CHANCE
MANUFACTURING CO., INC.

Service Information

Ride: SKYDIVER

Subject: CAR BODY FRAME

Latch Engaged In Slot In A-Frame

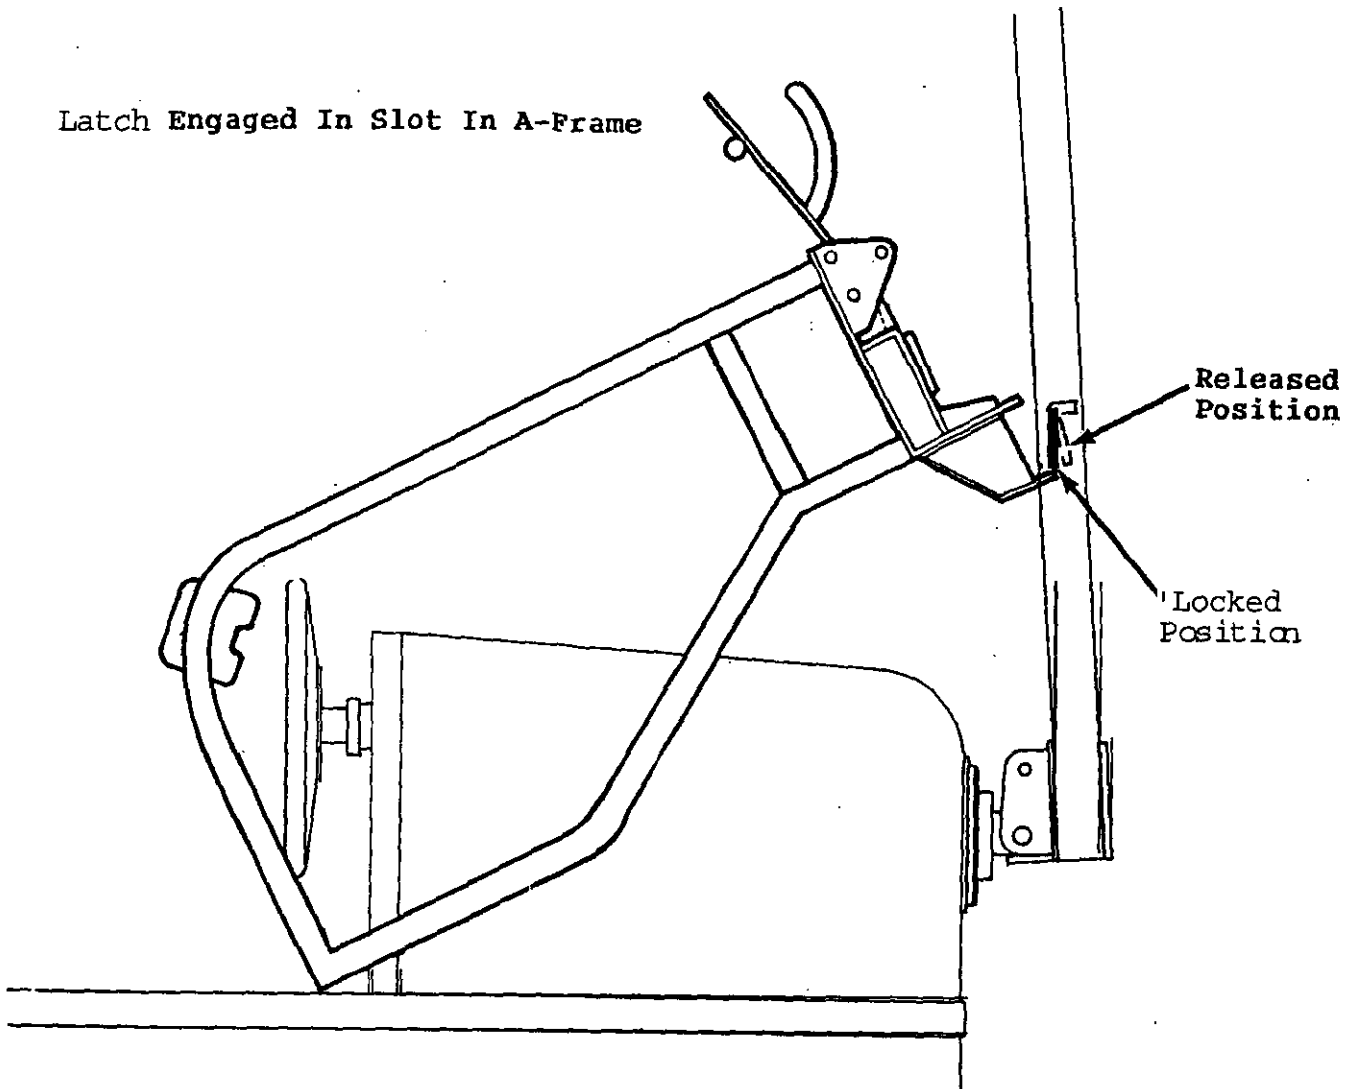
3. Rotate the hatch to the open position as shown and check to make sure that:

- The latch securely engages in the A-frame slot for loading and unloading (Locked Position).
- The latch will release properly when the latch release is disengaged (Released Position).

NOTE: If necessary, adjust the latch extension position slightly to obtain the correct engagement into the A-frame slot. Also, the tang of the latch extension can be ground shorter to allow the correct release from the latch.

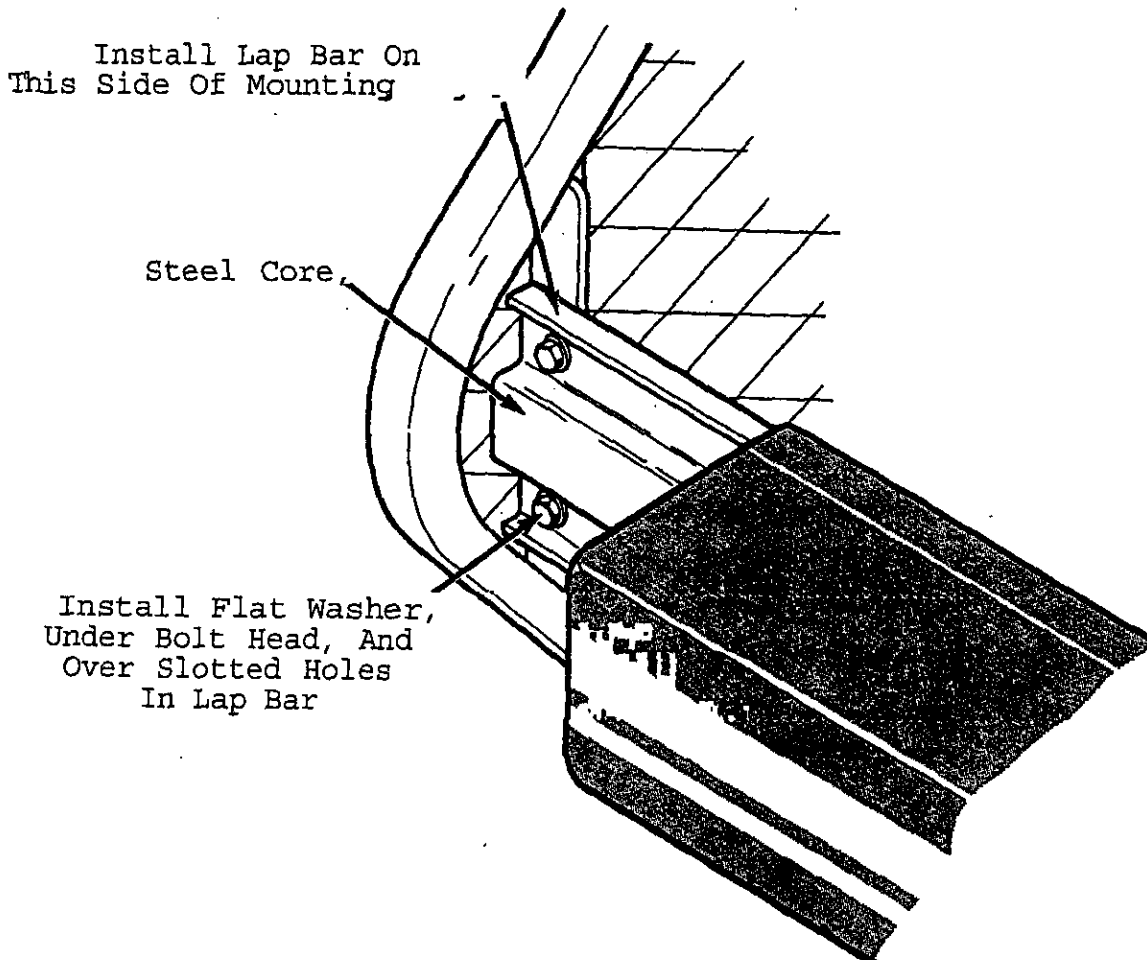
1. The lap bar must be identical to the lap bar shown below. The core must be formed steel. WOOD LAP BARS ARE NOT ALLOWED.
2. The lap bar must be installed exactly as shown. Tighten the mounting bolts to 5-6 ft-lbs.
3. Lap bar padding must be in good repair. Minor repairs to the factory padding are permissible, if its original size and shape are not altered.

DETAIL OF TYPICAL PLATFORM
WITH TAPER PIN AND HAIR PIN
CORRECTLY INSTALLED

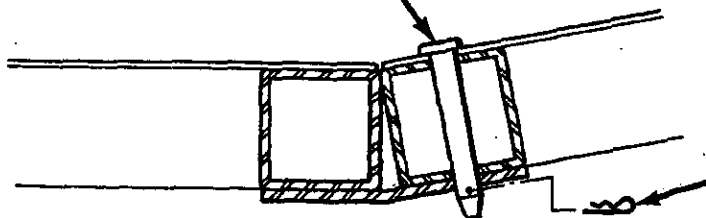
Inspect for proper installation of platforms and retainer pins as shown in the following illustrations. Each platform must be attached to the adjoining platforms with the taper pins and hair pins as originally provided from the factory. Never allow the platforms to simply lie in place. Likewise, do not use fasteners other than the pins originally specified.

ILLUSTRATION A

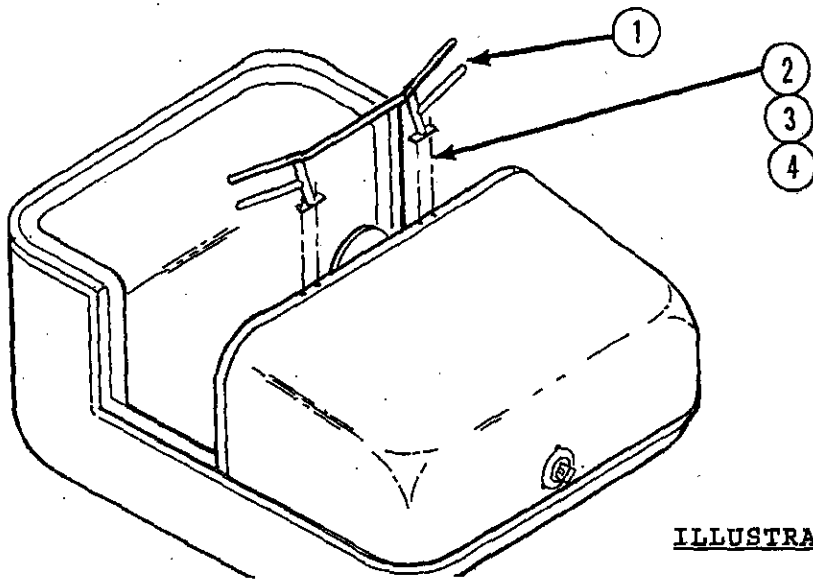
1. With vehicle hatch in the open position, remove and discard the existing grab rail (Illustration A) and fasteners. Do not install the new grab rail at this time.
2. Remove the steering wheel from the shaft (Illustration B). Save the acorn nut and key.
3. Place the guard plate (Item #5) over the steering wheel bearing. Use the plate as a pattern to locate and drill mounting holes. See Illustration B for hole sizes and locations.
4. Install the guard plate using the fasteners provided (Items #6, #7, #8 and #9).
5. Install the steering wheel using the existing key and acorn nut. The acorn nut should be secured with a liquid locking material.
6. Install the new grab rail (Item #1) using the fasteners provided (Items #2, #3 and #4). Install the capscrews going down through grab rail.

ILLUSTRATION B

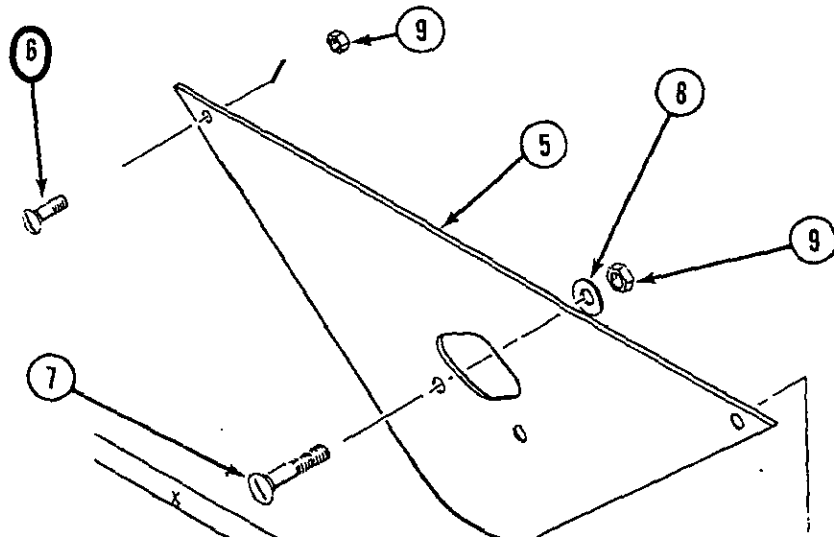
A modification kit has been developed to increase the clearance between the steering wheel and the grab rail, reducing the possibility of injuries due to pinched hands and/or fingers. Additionally, a guard plate installed behind the steering wheel eliminates a potential pinch point at the steering wheel bearing mount.
